THE 9

8822 9th Ave SW
Seattle, WA 98106

ADMINISTRATIVE DESIGN REVIEW

Project # | 3025366
Recommendation Packet
November 22, 2019

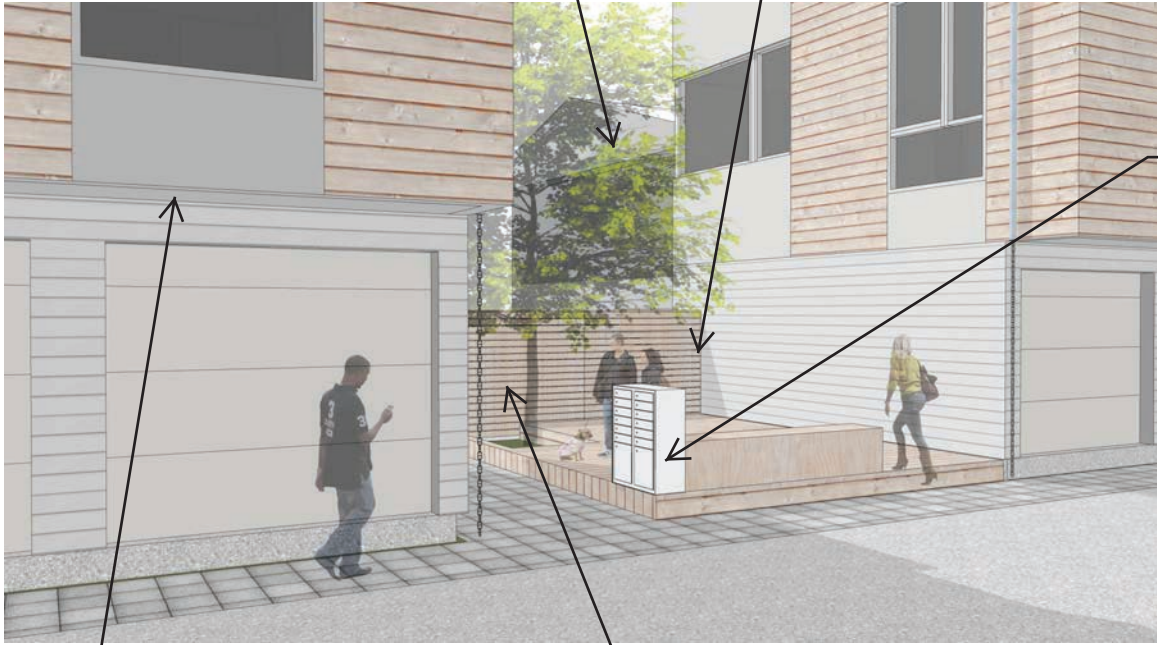
EDG Guidance 10/28/2019		Architect's Response
PRIORITIES & RECOMMENDATIONS		
2. Massing Option and Site Plan		
Staff supports aspects of the overall massing and varied site plan configuration proposed within Option 3, with the following modifications:

a) Switch the location of the parking to the north edge of the site and group the landscaped and open space areas on the south edge of the site, to better comply with design guidelines related to landscaping, minimizing the impact of parking, and access to sunlight (CS2.B, PL1.A, DC1.C, DC2.A).	We have switched the parking to the north side, which reduced the impact of parking. This allowed a green space to develop between the two buildings.

b) Reconfigure areas no longer required for parking access (such as the space between the east and west buildings) as shared, usable landscaped space. (CS2.B, PL1.A, DC1.C, DC2.A).	The space between the two buildings has been revised to be a greenspace.

c) SDCI advises the applicant to communicate with SPU regarding the location and size of waste removal area(s) on-site (DC1 – Project Uses and Activities).	We have been in contact with SPU on our solid waste plan. We have increased our solid waste storage size. In addition, the asphalt truck turnaround has increased in size to accommodate the truck size and turning radius. We have located the solid waste away from pedestrian views.

d) Retain a varied arrangement of masses, as shown on the proposed Option 3 site plans, especially on the southern facades (DC2.A).	We have retained the varied massing site plan. This breaks the site up into zones and helps create small communities.

Varied arrangement of massing has been retained, creating dynamic spaces

Area between buildings has been landscaped and added large trees

Ornamental plant provides focal point at end of alley axis

Space between buildings has been designed to include a greenspace and community area

Site plan and paving has been redesigned to enhance SPU and fire truck access

Impact of parking has been minimized by moving it to north end of site

Trash enclosure is easy to access but visually subdued with cedar fencing

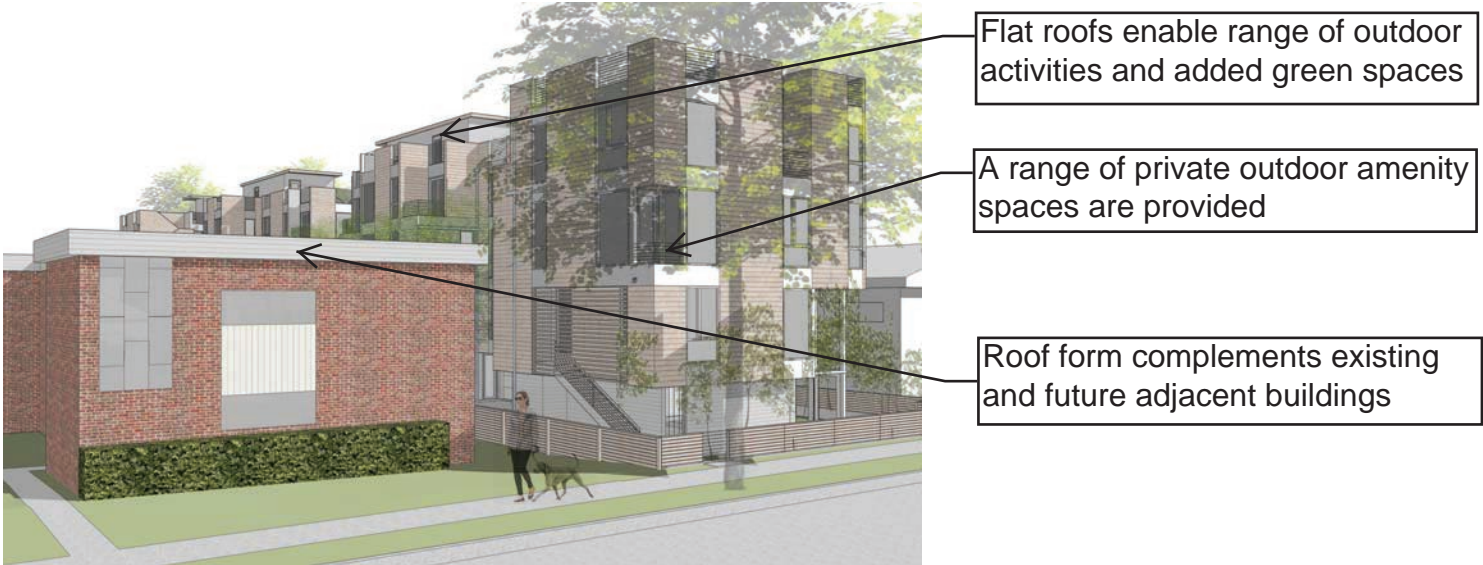
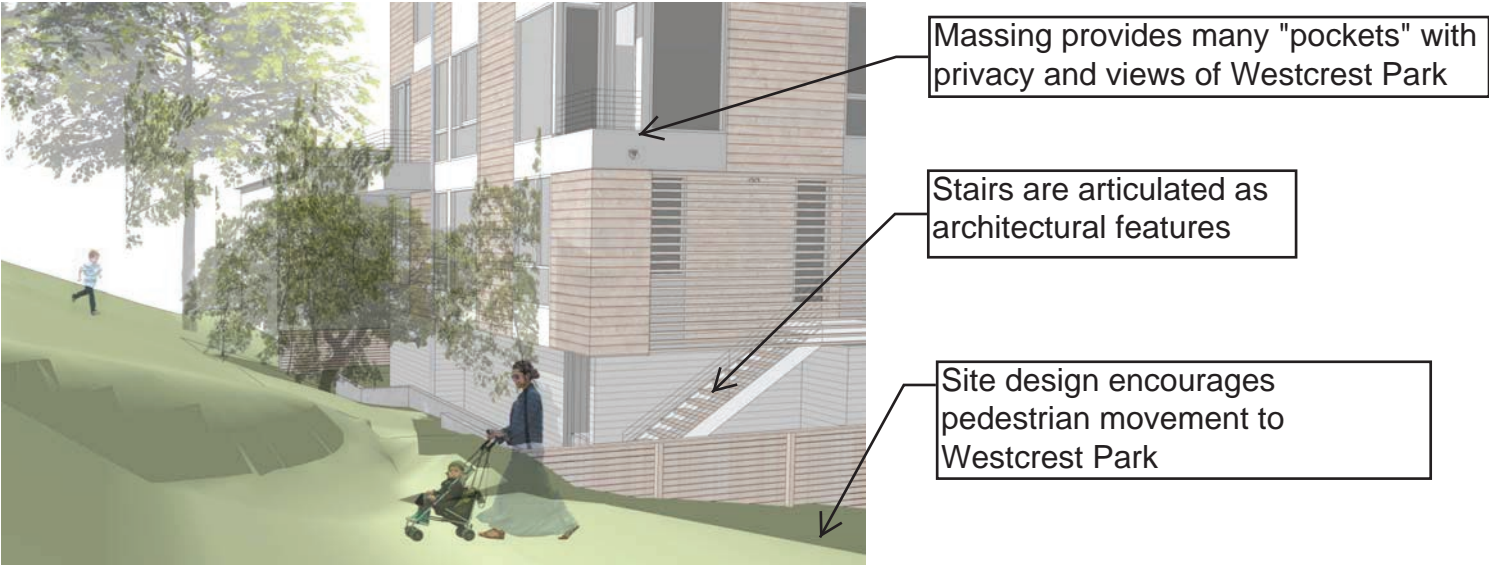
EDG Guidance 10/28/2019		Architect's Response
PRIORITIES & RECOMMENDATIONS		
3. Design Concept and Form		
	a) Design the location and façade treatment to minimize the appearance of the stair towers (DC2).	We have removed penthouses and updated 5 of the 12 townhomes to exterior stair access. The penthouses that remain are in the middle of the site and not visible from 9th Ave SW.

b) Modify the roof forms to better respond to context and massing. (DC2 – Architectural Concept). <ul style="list-style-type: none"> i. Explore pitched and gabled roofs that will contribute to neighborhood character. ii. Demonstrate how the roof design responds to nearby context, including single-family homes with pitched roofs across 9th Ave. S. iii. Sawtooth roofs, if oriented to provide the consistency and harmony and to fit with neighboring residential context, could be one of several appropriate options. 	<p>The neighborhood roofs are not consistently pitched, flat, or sawtoothed. The two buildings directly north or our site have flat roofs. Many of the new developments on the block will have flat roofs with rooftop access. The flat roof allows the units to have private amenity space on the roof, which they lack on the ground floor.</p> <p>We explored sawtooth (Massing Option 2 in EDG) and pitched in our preliminary schematic designs. Functionally the flat roof allows for more useable space and it aesthetically matches the new developments and some existing buildings.</p>

c) Demonstrate a clear architectural concept (DC2 Architectural Concept, CS3).	This massing creates privacy, dynamic spaces, and well-lit interiors. See site plan and renderings.

d) Provide the following drawings with the MUP application to demonstrate the proposed design concept: <ul style="list-style-type: none"> i. Demonstrate the proposed massing forms, unobscured by shadow from neighboring buildings. ii. Axonometric drawings at ground-level, and street-level elevation drawings (looking southeast from 9th Ave. S., and looking directly east at the western street-facing façade) that clearly show the proposed street-facing facade. iii. Plan drawings that clearly show the location of adjacent building footprints. iv. Amend the existing context images from the EDG packet with description(s) that specify which, where, and how elements of the images included in the packet are intended to be integrated into the development and/or include images that realistically present the appearance of future development. 	See Recommendation and MUP application with all the drawing requests added.
